UNITED STATES DEPARTMENT OF THE INTERIOR **BUREAU OF LAND MANAGEMENT**

SUNDRY NOTICES AND REPORTS ON WELLS Do not use this form for proposals to drill or to re-enter an abandoned well. Use form 3160-3 (APD) for such proposals.					NMNM96782	
abandoned we	6. If Indian, Allottee or Tribe Name					
SUBMIT IN TR	IPLICATE - Other instruc	tions on reverse side.	EIVED	7. If Unit or CA/Agro	eement, Name and/or No	
. Type of Well	8. Well Name and No. FEDERAL "27" 2					
☑ Oil Well ☐ Gas Well ☐ Other						
Name of Operator FASKEN OIL AND RANCH L	9. API Well No. 30-025-29400

Federal "27" No. 2 560' FSL & 660' FEL Sec 27, T18S, R33E API #30-025-29400 A.F.E. 3421

Fasken Oil and Ranch LTD Federal "27" - 02, API 3002529400 T18S-R33E, Sec 27, 560FSL & 660FEL November 01, 2016

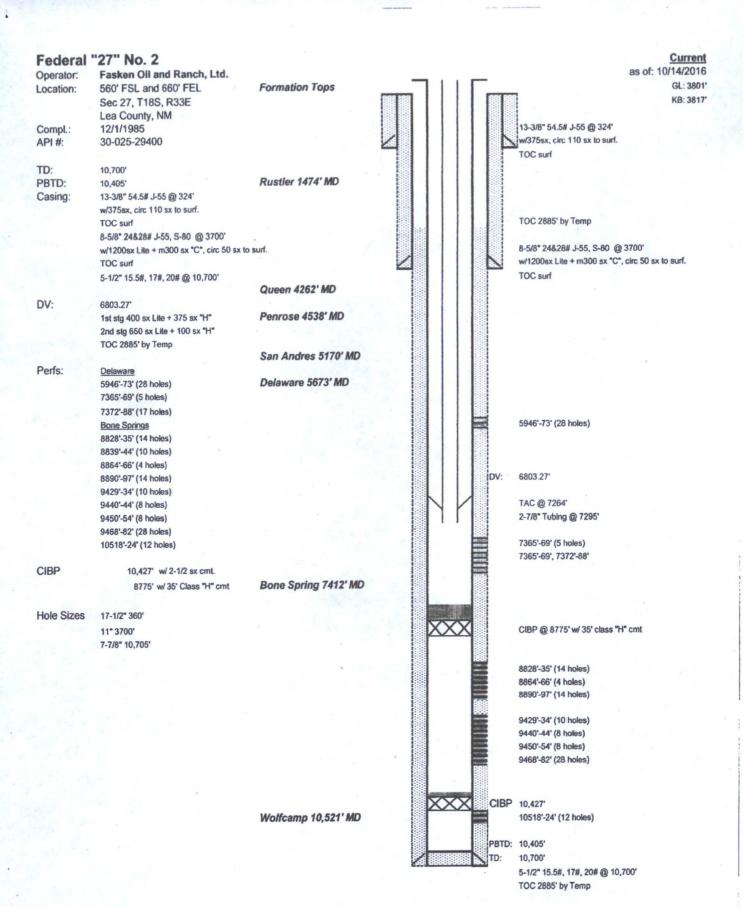
- 12. Remove the CIBP at 8775 and tag the CIBP at 10427.
- 13. Set a balanced Class "H" cement plug from the PBTD near 10427. Tag the plug with tubing at 10170 or less.

- 14. Reset a CIBP within 100ft of 8828. Set a balanced Class "H" cement plug from the CIBP above 8828. Tag the plug with tubing at 250ft above the CIBP.

- 15. Set a balanced Class "H" cement plug across the Bone Spring formation top from 7550. Tag the plug with tubing at 7300 or less.
- 16. Set a CIBP at 5900 and dump bail a 35' cmt cap or place a 25sx Class "C" cement plug on the CIBP. Tag the cmt plug
